MIL-R-83536/22
AMENDMENT 2
15 December 1995
SUPERSEDING
AMENDMENT 1
23 September 94

MILITARY SPECIFICATION

RELAYS, ELECTROMAGNETIC, ESTABLISHED RELIABILITY, 3PDT
LOW LEVEL TO 10 AMPERES, PERMANENT MAGNET DRIVE, HERMETICALLY
SEALED, ALL WELDED, TRANSIENT SUPPRESSED DC COIL

CIRCUIT DIAGRAM
(ALTERNATE INTERNAL
DIODE CONFIGURATION)

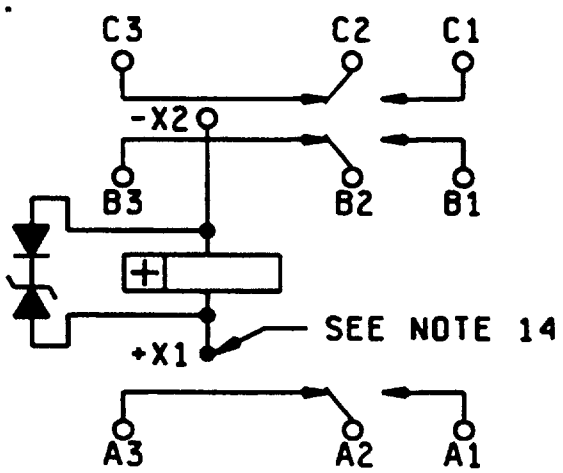
* FIGURE 1, above figure title Add "CIRCUIT DIAGRAM"

* FIGURE 1 add the following circuit diagram
